TOWN OF UNDERHILL

Development Review Board

SCOTT & AMELIA TOWER
CONDITIONAL USE: WAIVER REQUEST HEARING
Docket #: DRB-19-11

Applicant(s):	Scott & Amelia Tower
Consultant:	Robert Linde
Property Location:	73 River Road (RV073)
Acreage:	± 2.50 Acres
Zoning District(s):	Rural Residential and Water Conservation
Project Information:	The Applicants have constructed an addition to a deck, which encroaches into the west, side property setback.

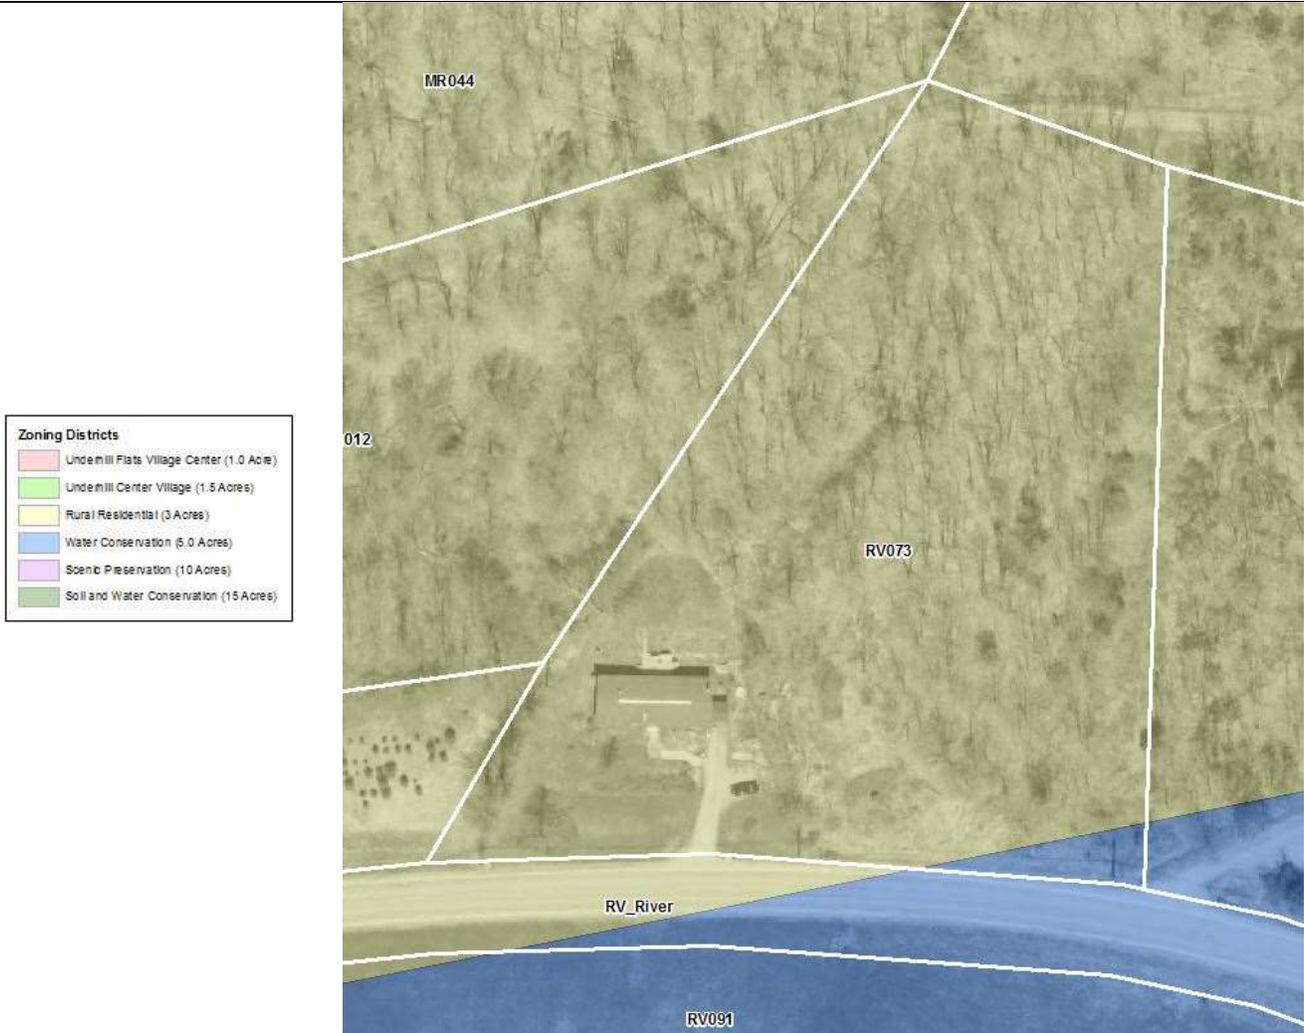
- The ANR Atlas depicts areas of steep slopes (15%-25%) or very steep slopes (>25%) in the project area (see directly to the right).
 - While the proposed project (deck addition) does not appear to be located within any areas of steep slopes or very steep slopes, building the deck addition inside the existing “building envelope” is unlikely due to the “building envelope” being tightly confined resulting from the setback requirements and the abundance of steep and very steep slopes.
